To: Bidders for the *Oak Brook Park District- Central Park Improvements*

SUBJECT: ADDENDUM NO. 1 TO THE BIDDING DOCUMENTS FOR:
Oak Brook Park District – Central Park Improvements
Bid Group #1 Bid Packages 1 - 19

Project No. 07-5646-04

QUESTIONS AND ANSWER LOG

10 ASPHALT PAVING - PEDESTRIAN
SCALE: 1" = 1'-0"

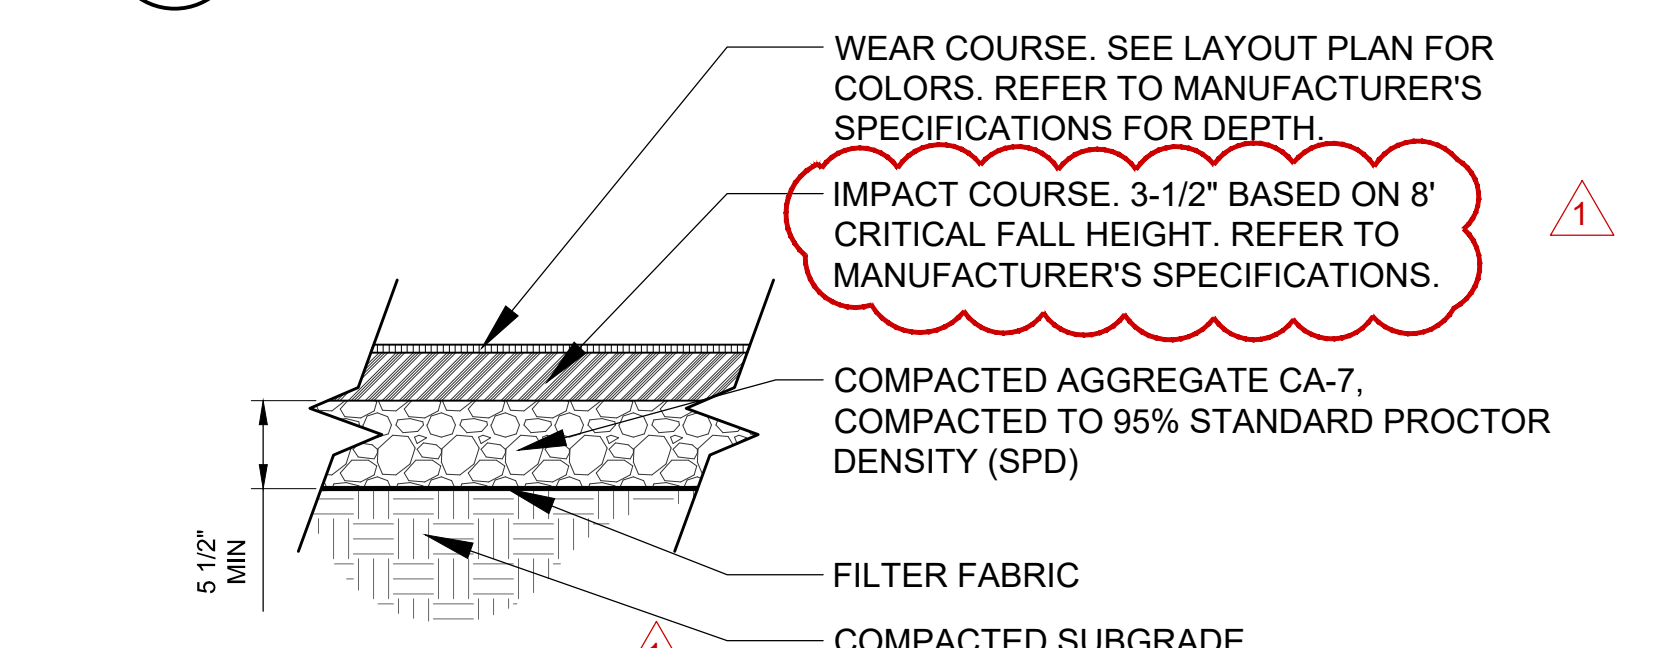
1. 10/SD4.01- ASPHALT PAVING PEDESTRIAN- revised depth of binder course.
2. 11/SD4.01 – PLAY SURFACING- POURED IN PLACE- Indicated depth of base course. Revised subgrade pitch note.
3. 10/SD4.02 – RUBBER TILE- Added detail.
4. 1/SD4.03 – CONCRETE STEPS- Added additional risers and rail post.
5. 4/SD4.05 – WALL ELEVATION A- Added elevations to top of wall
6. 5/SD4.05 – WALL ELEVATION B- Added elevations to top of wall
7. 7/SD4.05 – DUGOUT ELEVATION- Added middle rail to fence panel on side of dugout

1 WOOD ENCLOSURE - GATE
 1/2" = 1'-0"

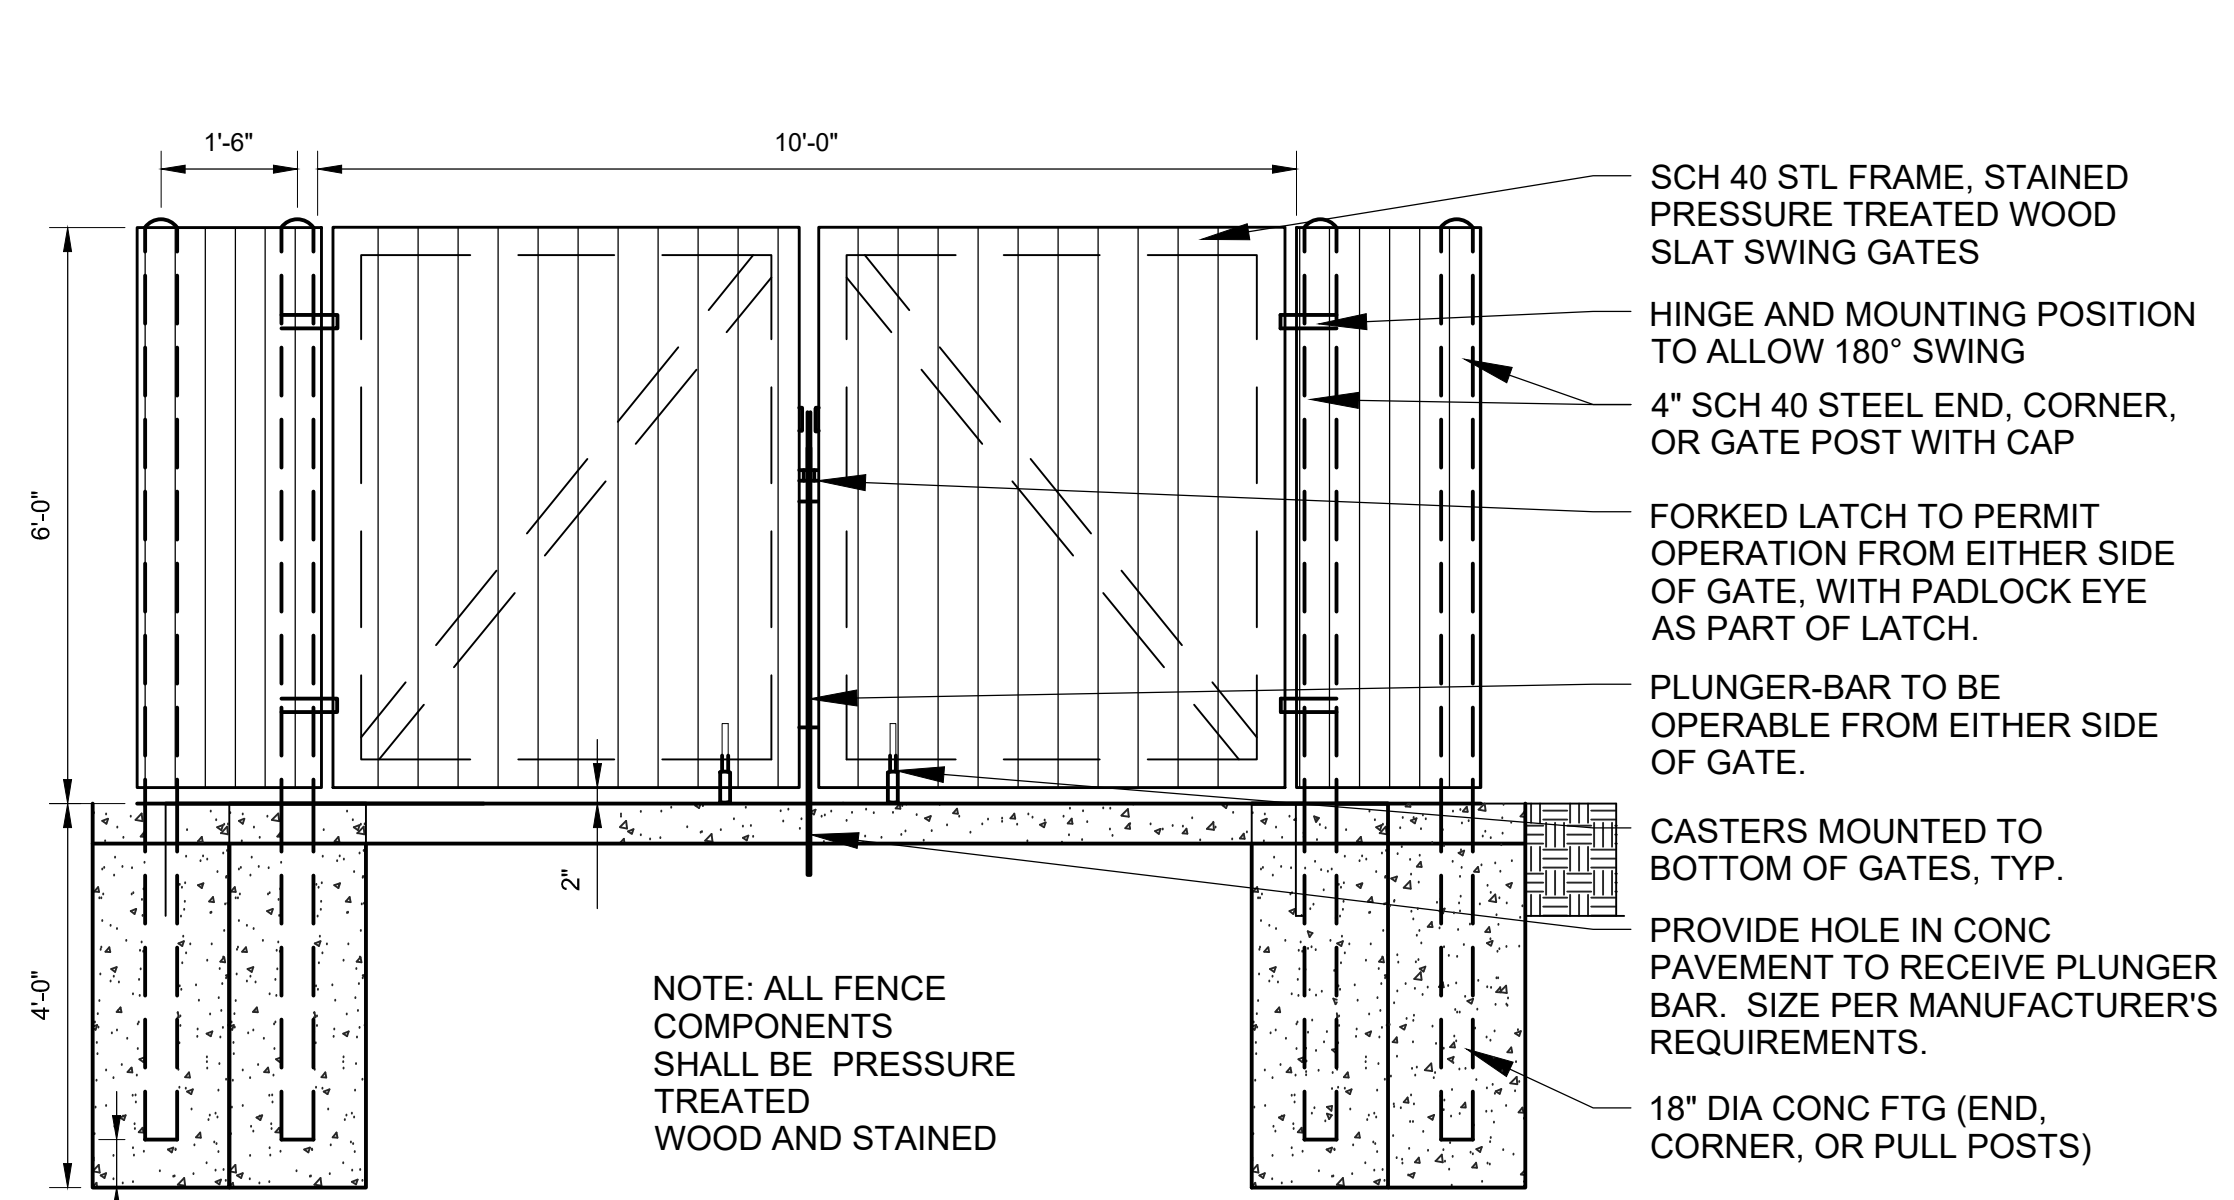
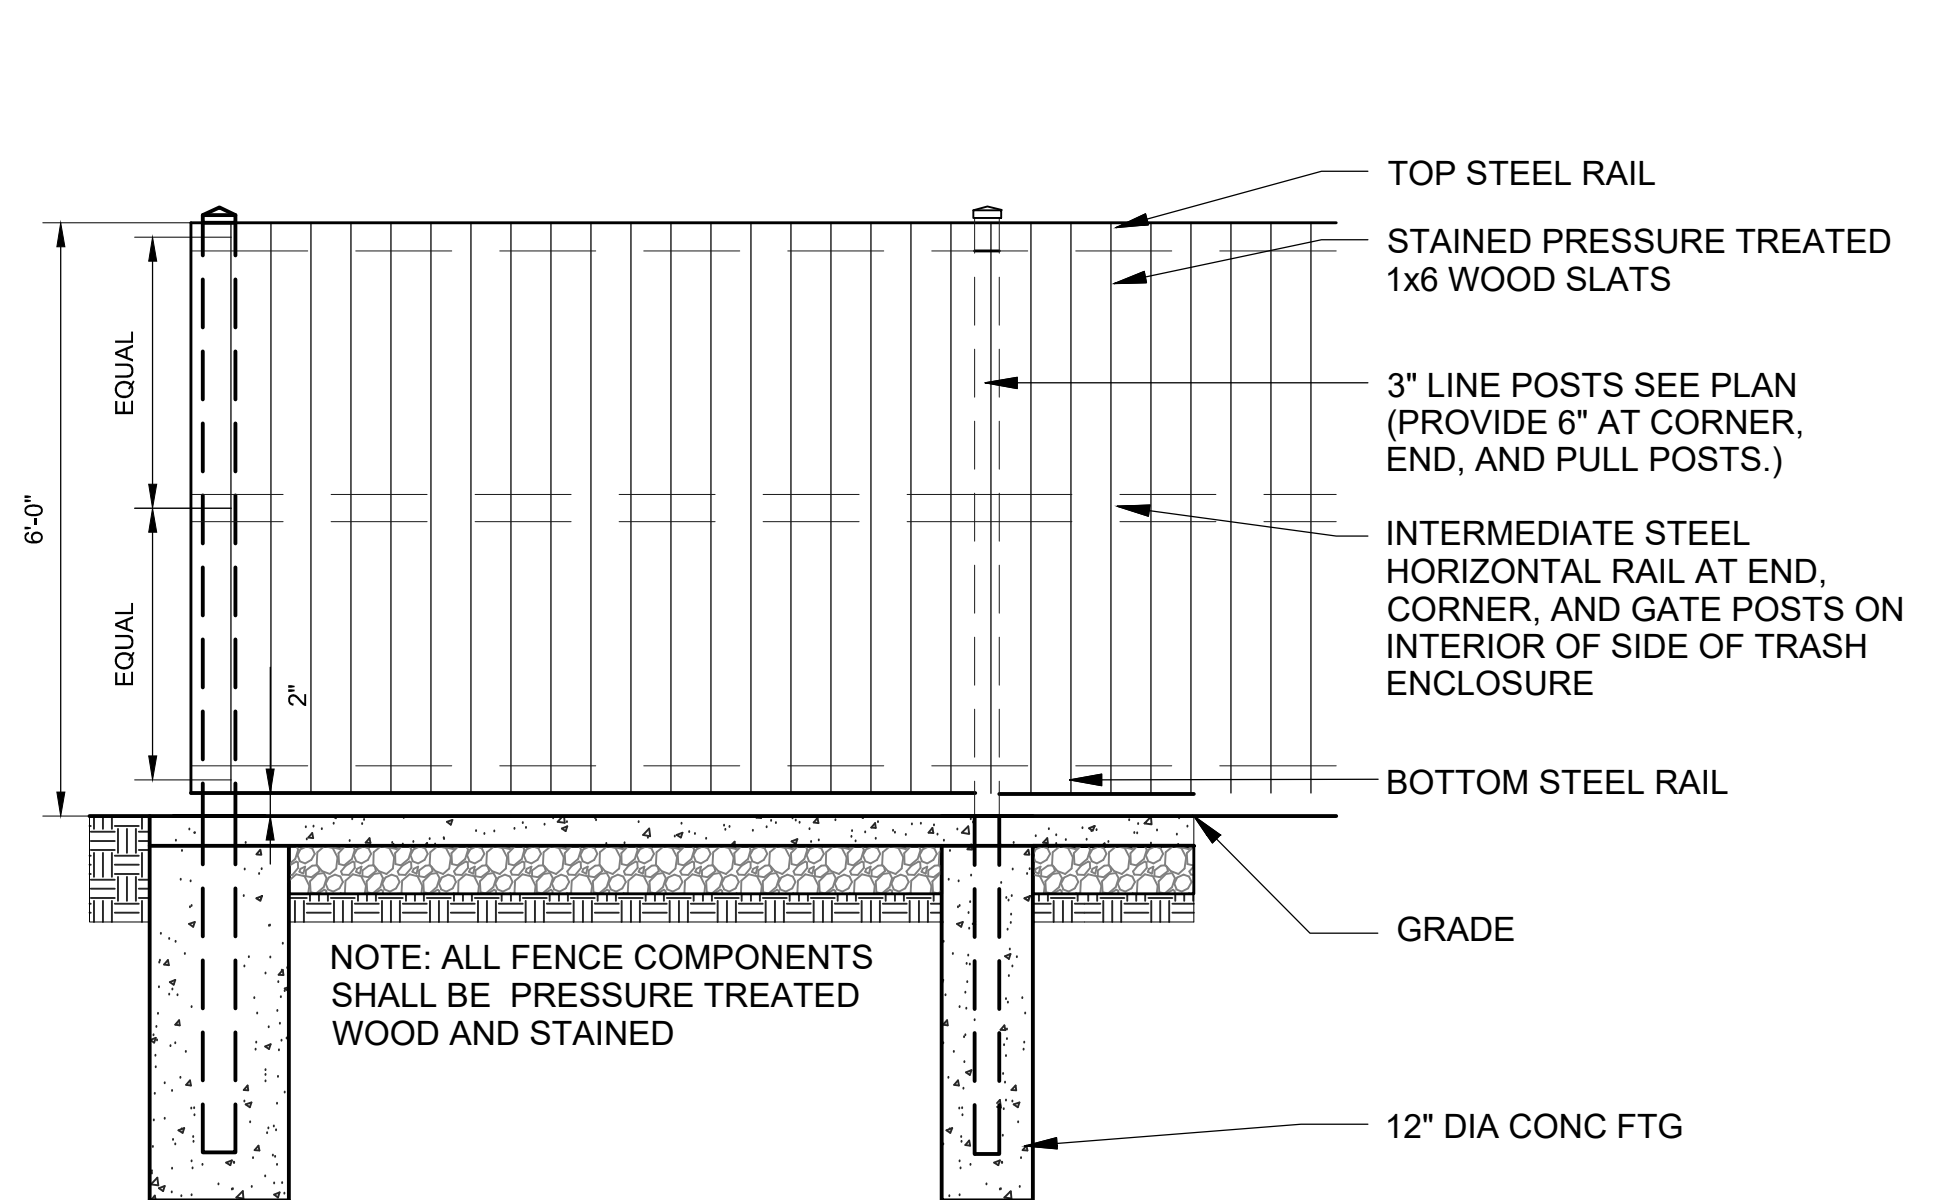
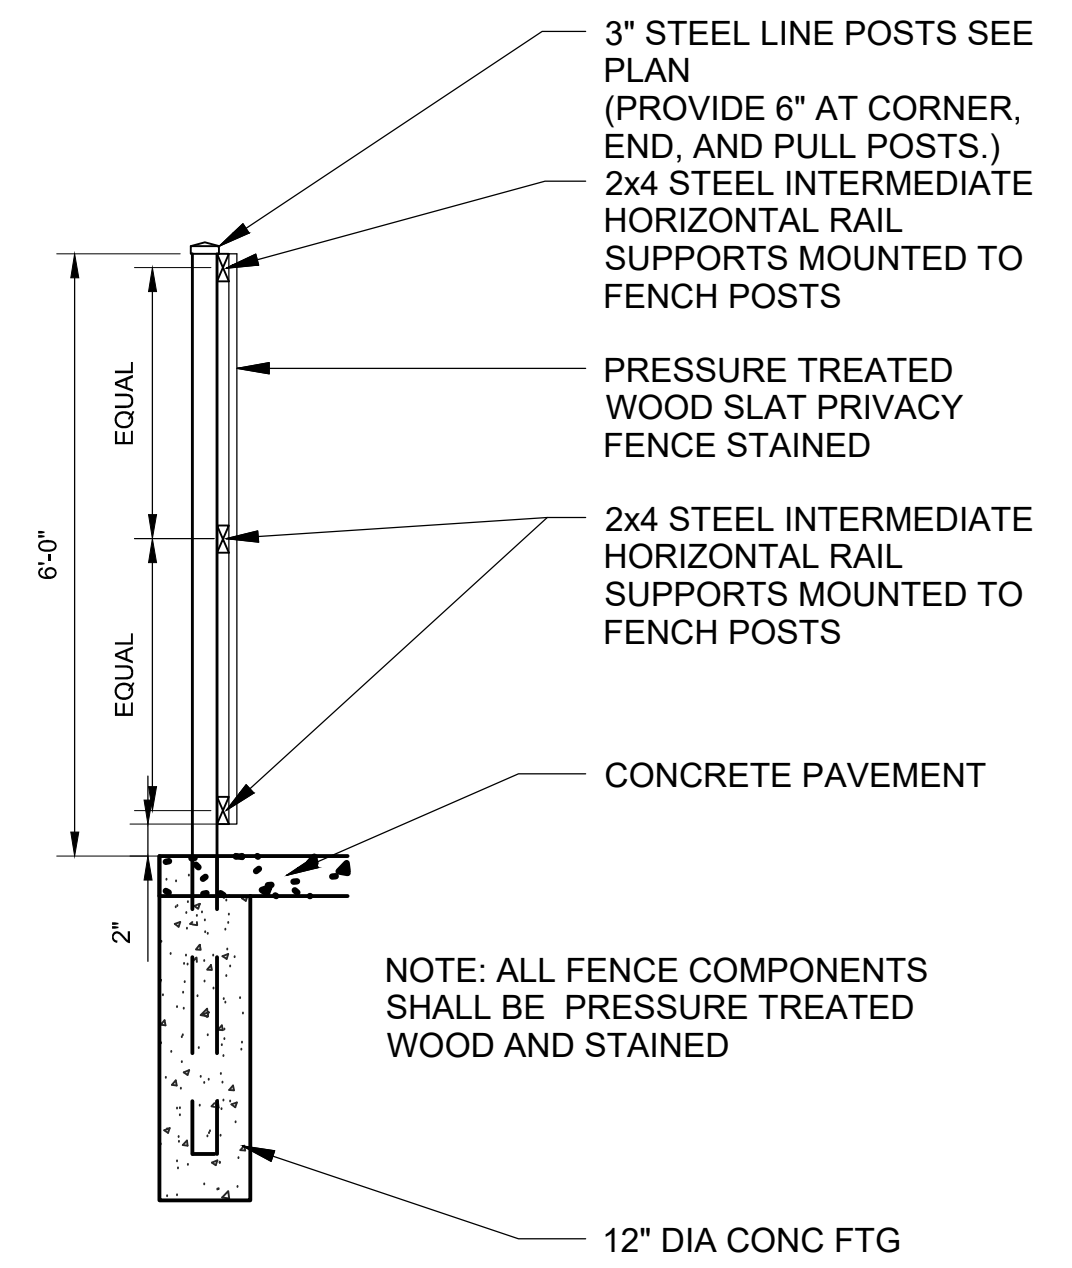
8. SD4.07 – Detail sheet added with wood enclosure and accessible curb ramp.
9. SD4.08 Detail Sheet added for specific Permeable Paver BMP #1 area located at the north parking lot. Contractor to slope subgrade as specified and verify BMP Volume required per County Code with as-built topo survey.
10. SD4.09 Detail Sheet added with the following details: 2' Inlet, 3' Catch Basin/Inlet, Curb Cut Detail and Nyloplast Drain Basin Detail.

#	Questions	Answers
1	Please provide fence details for the wooden trash enclosure fence and gates.	Fence details have been provided with this addendum
2	Please advise if the ornamental fence as detailed on drawing SD4.02 is part of the fence bid package. On drawing SD2.04 shows the ornamental fence layout. one of the notes on the north side says "By others".	The ornamental fence is part of the bid package 'By Others' has been removed.
3	Specification section 323113-6,2.6C. custom barrier net. Reference order #0285282. The manufacturer quoted this with steel poles. Detail #8 on drawing SD4.05 calls for 4" o.d. aluminum poles with ground sleeves. The manufactures is asking the following questions: 1. Are the poles aluminum or steel? 2. Do you want the poles to be permanently set or in ground sleeves? 3. Are the nets to be permanently installed or with hoisting ropes?	1. Poles will be steel. 2. Poles will be permanently embedded. 3. Nets will be installed with hoisting ropes.
